SUBSURFACE WASTEWATER DISPOSAL SYSTEM VARIANCE REQUEST

| System's Location: | <u>60 Dole Drive</u> | |

SUBSURFACE WASTEWATER DISPOSAL SYSTEM APPLICATION

SUBSURFACE WASTEWATER DISPOSAL PLAN

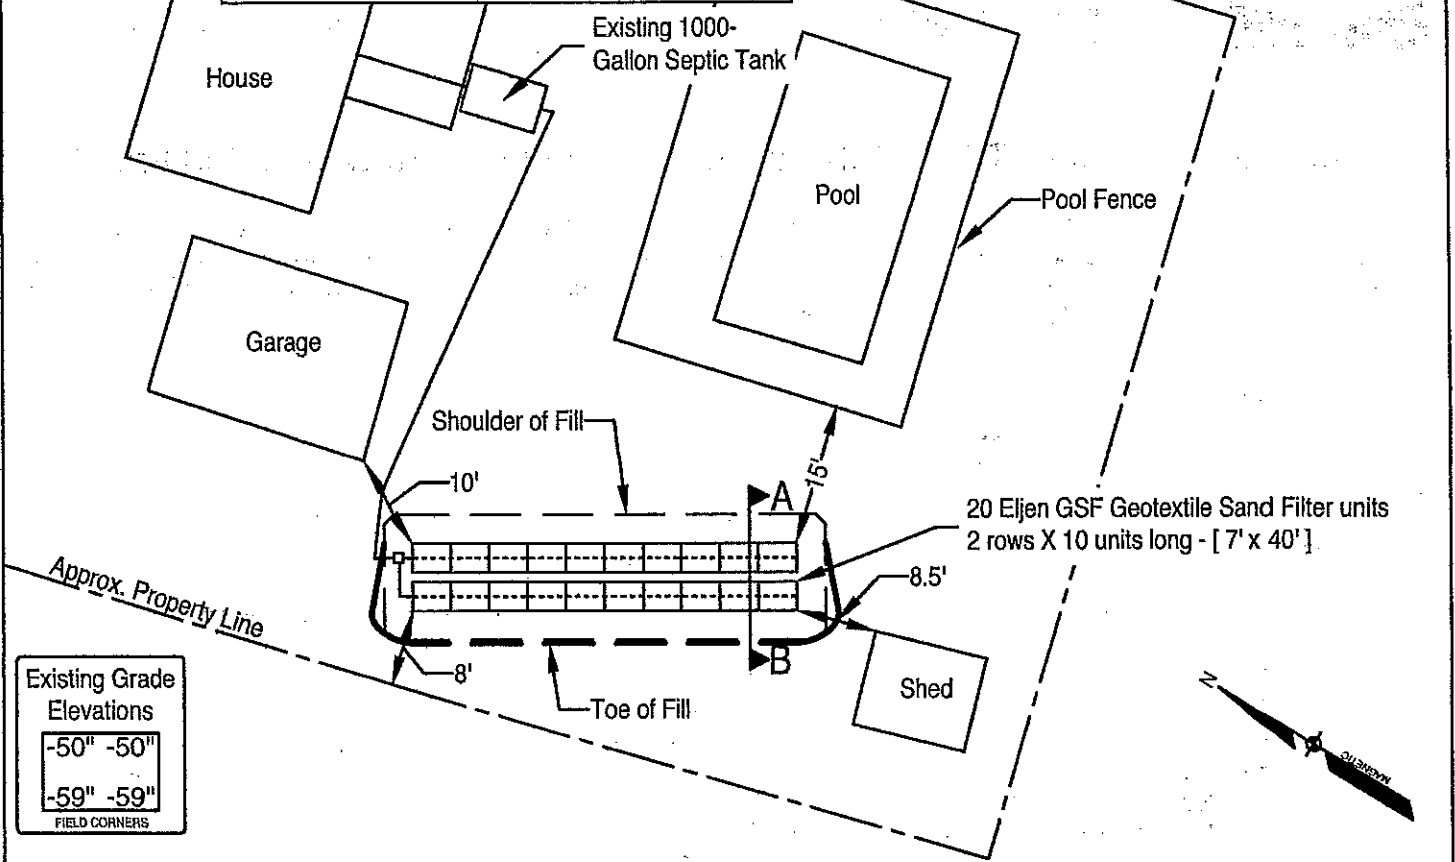
| SPECIFIC VARIANCE REQUESTED (To be filled in by Site Evaluator. Use additional sheets if needed.) | SECTION OF RULE |
|---|-----------------|
| 1. <u>Reduce separation from leachfield to property line from 10' to 8'</u> | <u>Table 8A</u> |
| 2. <u>Reduce separation from leachfield to garage from 15' to 10'</u> | <u>Table 8A</u> |
| 3. <u>Reduce separation from leachfield to shed from 15' to 8'</u> | <u>Table 8A</u> |

Necessary to replace failing 1968 septic system.

I, Douglas R. Noen, the undersigned, have visited the above property and find that the variance request submitted by the applicant does not conform with certain provisions of the wastewater disposal rules. The variance request submitted by the applicant is the best alternative for a subsurface wastewater disposal system on this property. The proposed system (does does not) conflict with any provisions controlling subsurface wastewater disposal in the shoreland zone. Therefore, I (do do not) approve the requested variance. I (will will not) issue a permit for the system's installation as proposed by the application.
